Proj. No.: H0562C  
File Loc.: Westminster

California Regional Water Quality Control Board  
Central Coast Region  
895 Aero Vista Drive, Suite 101  
San Luis Obispo, CA 93401

**RE: REVIEW OF OLIN STATEMENT REGARDING NORTHEAST FLOW**

4/2006 *See 4/28/2006*

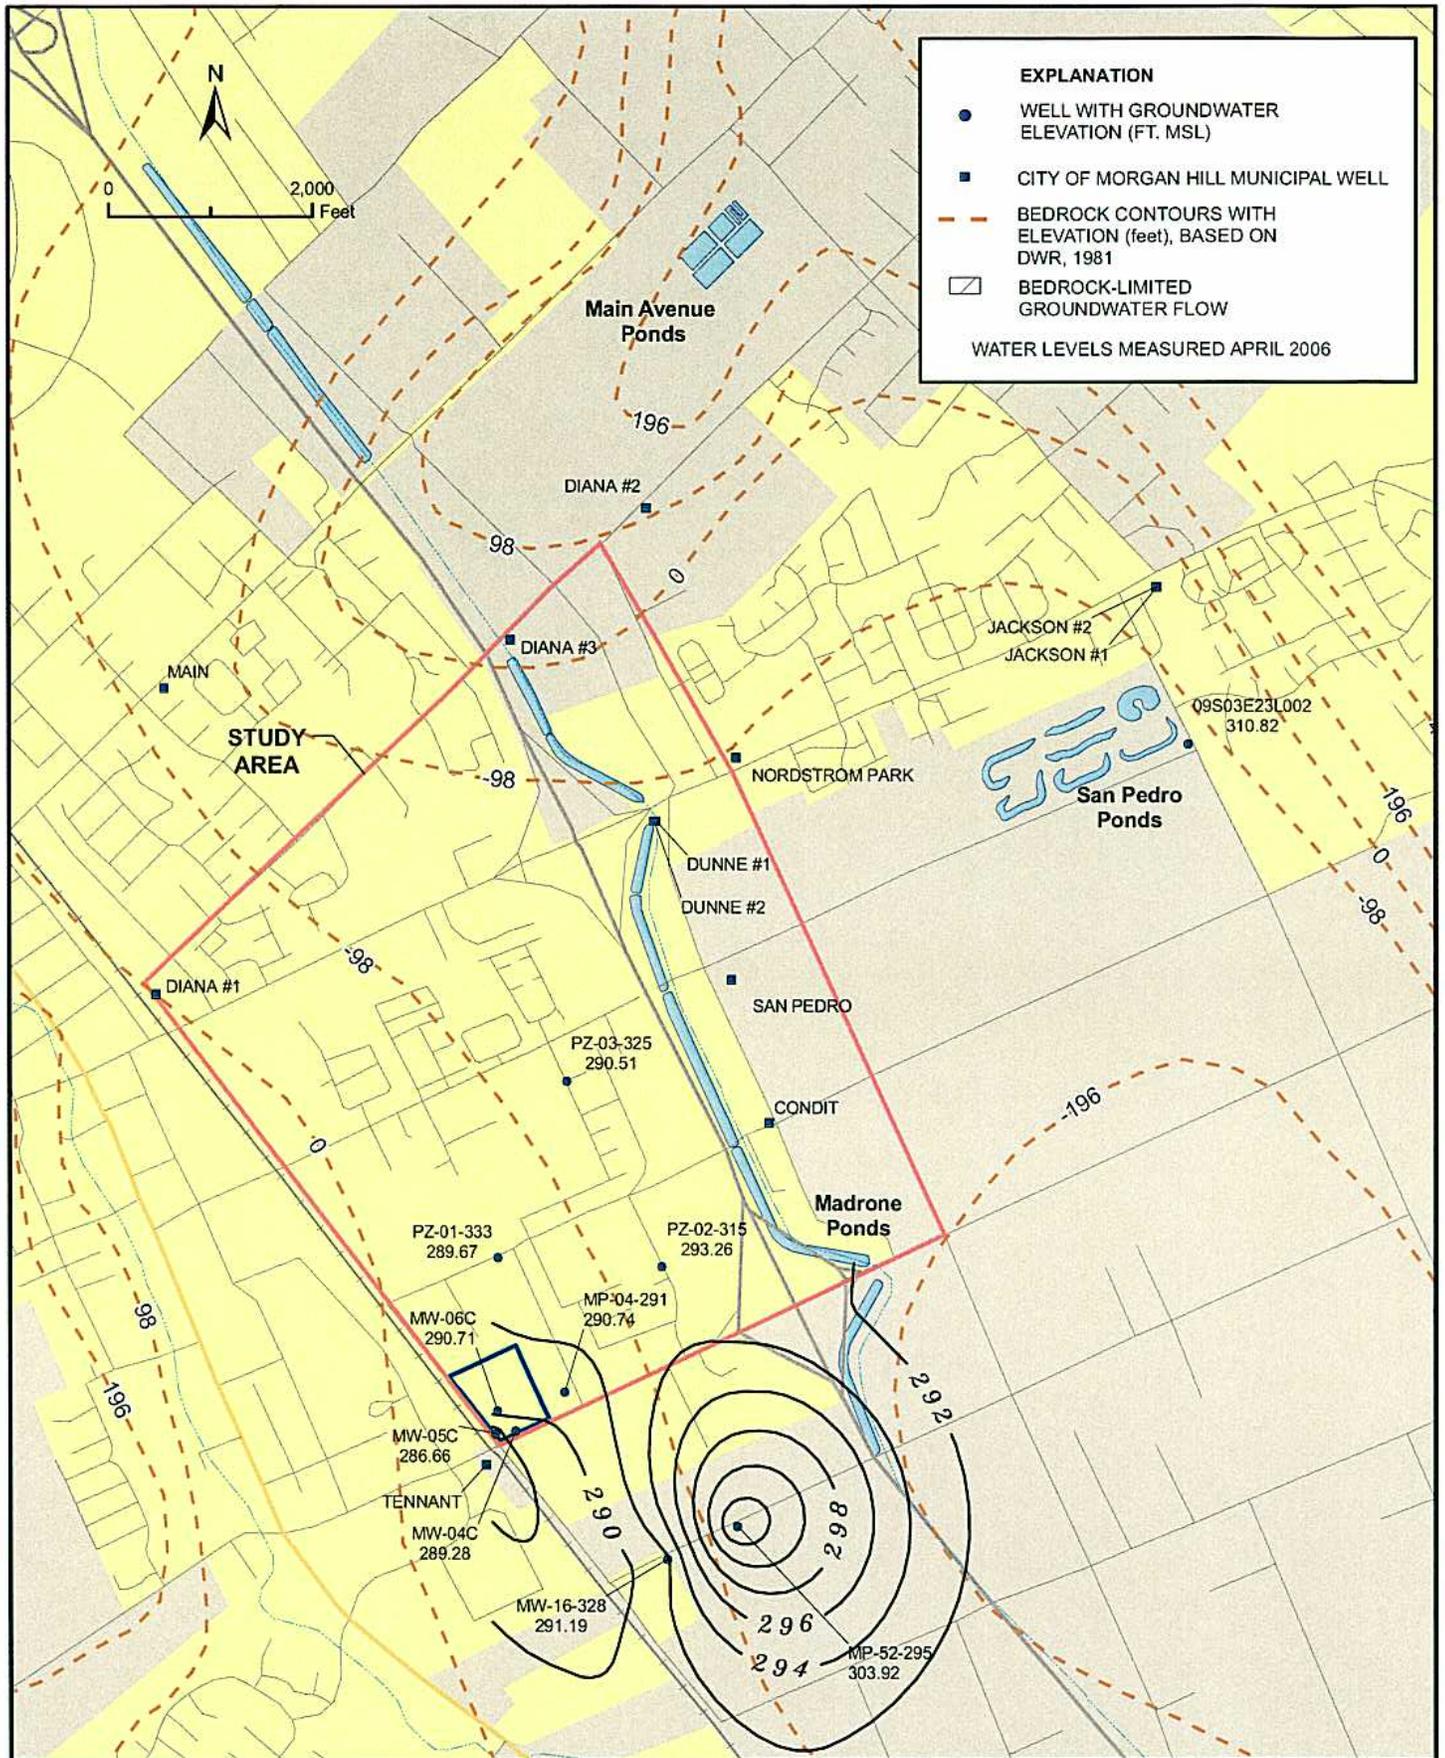
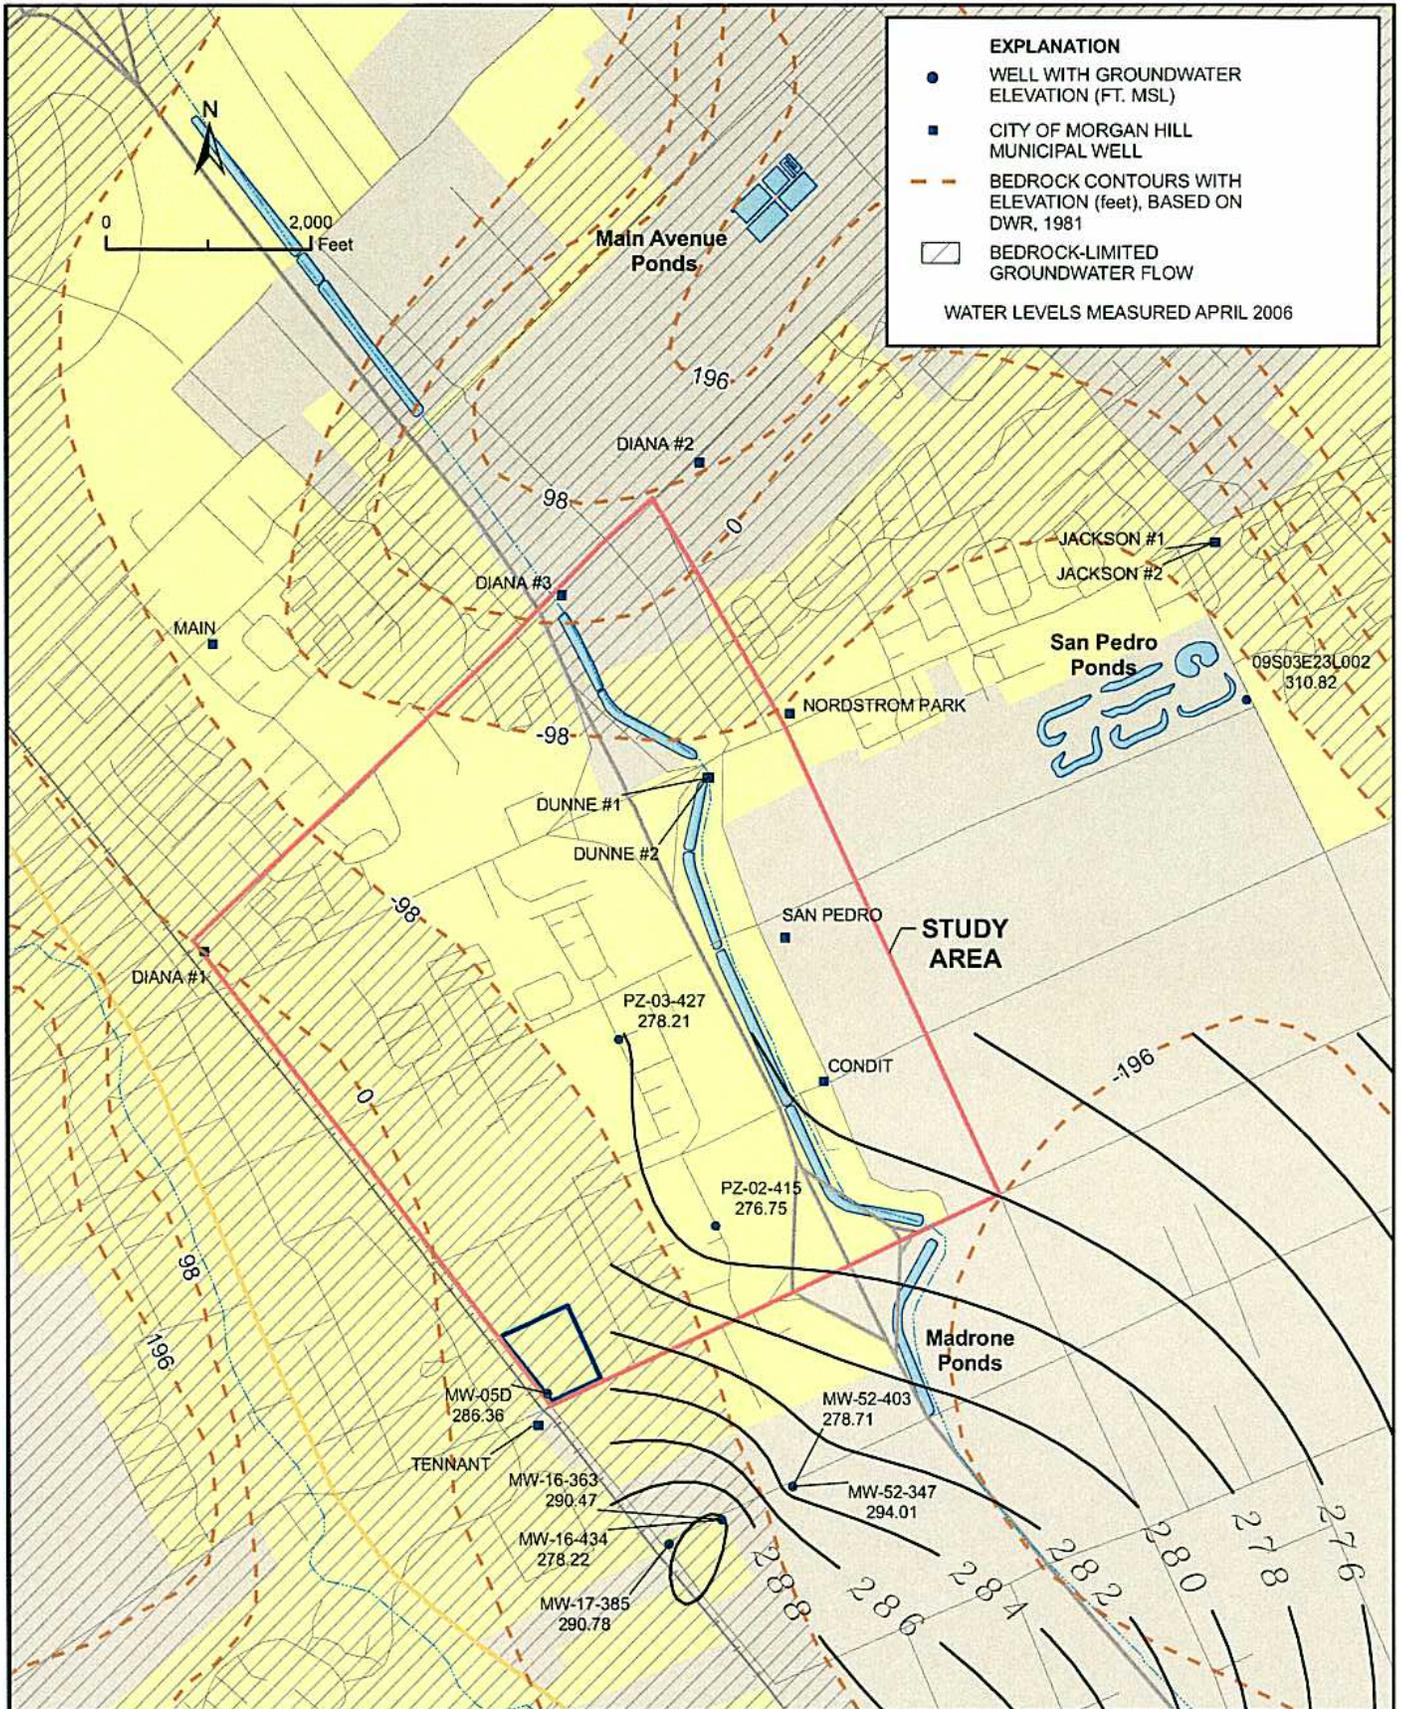
- c. Gradient maps generated by Olin's consultant showing north and northeasterly flow in the deep aquifer zone, using data from the northeast piezometers for one year, dating back to summer of 2005 in Attachment 2.3 (for Q3, 2005, Q4, 2005, Q1, 2006 and Q2, 2006); and,
